**Consumers
Power
Company**

Subject: Midland Energy Center GW07020
Auxiliary Building Underpinning
NRC Audit of September 14-15, 1983
and Subsequent Discussions
File: 0485.16 UFI: 42*05*22*04 Serial: CSC-6960
12*32

This letter summarizes the discussions during the subject audit. It also includes the applicants' responses to the open items resulting from the subject audit and the subsequent discussions.

FIGURE - 7 , ATTACHMENT-3

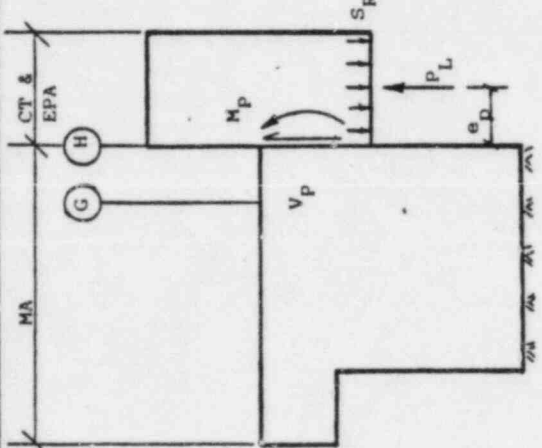
1. Building stresses after lock-off of the permanent wall with regard to residual stresses and upward building movements during underpinning.

The effect of applying permanent jacking load has been schematically shown in Figure 7. Due to the existing condition a Shear V^e and a moment M^e occur at the interface of the Main Auxiliary and the Control Tower as shown in Figure 7 (a). Existing stresses are caused due to these forces. Due to the soil removal and the application of permanent jacking load, shear V^p and moment M^p are caused at the interface as shown in Figure 7 (b). Stresses, opposite in nature to the existing stresses, are caused by these forces. As shown in Figure 7 (c), the existing shear and moment are eliminated, after the application of the permanent jacking load if the jacking load equals the tributary weight of the EPA and Control Tower; and the jacking load is applied at the center of gravity of the tributary load. Since the applied load is not exactly equal to the tributary load and there is a small eccentricity between the jacking and the tributary load (see Figure 6), small residual shear and moment remain in the structure causing small residual stresses.

For example, the existing stress in the slab at El. 659' before the start of underpinning was approximately 14.3 ksi tension with load factor. At the end of permanent jacking, this tensile stress is reduced to a small amount (2.1 ksi).

In the analytical model for the analysis of the permanent wall, neither of the loading conditions presented in Figures 7 (a) and (b) are considered, as they essentially neutralize each other as explained above. Therefore,

FIGURE 8

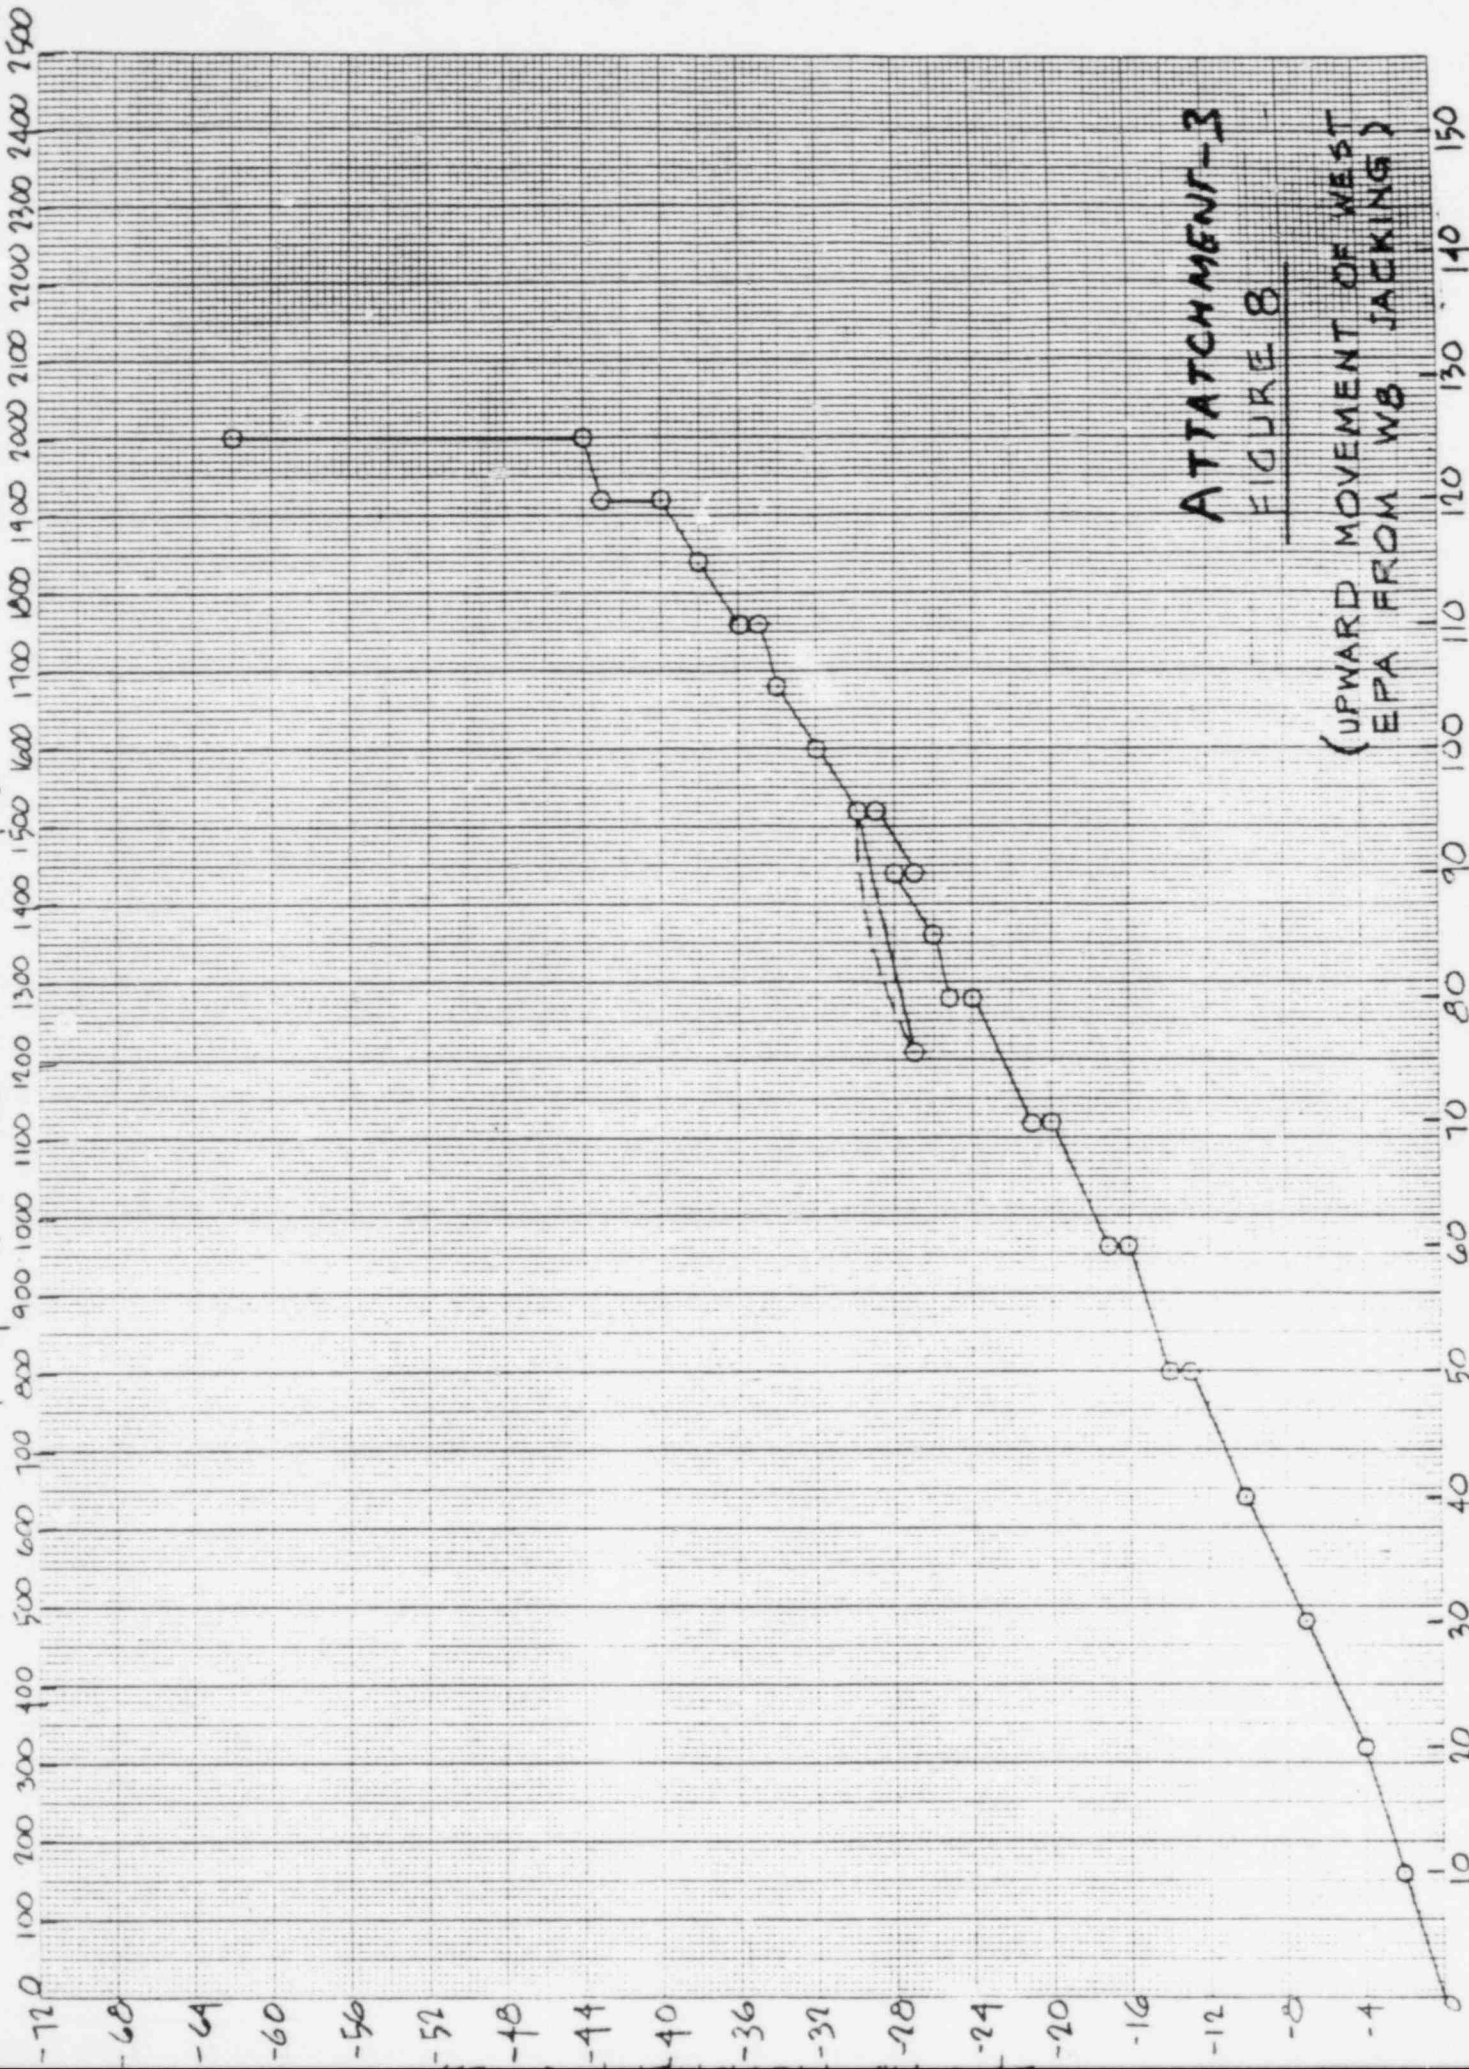
1. Approximately how much upward movement of the existing structure (EPA and Control Tower) will be allowed during jacking operations?
2. How was the value (and conditions related to value) in Answer No. 1 determined?

As temporary and permanent jacking are progressively applied, the elastic settlement will generally be recovered, (i.e., the building will move up). The phenomenon was confirmed during the jacking of the grillage beams at E/W8 (see Figures 8 and 9). The observed upward movement here was approximately 60 mils for the West EPA and 80 mils for the East EPA for the jacking load of 2,000Kips. Part of this upward movement can be attributed to atmospheric changes in temperature. Calculated values of upward movement, during the jacking, are only approximate and will vary from observed values because of the following factors in the analysis:
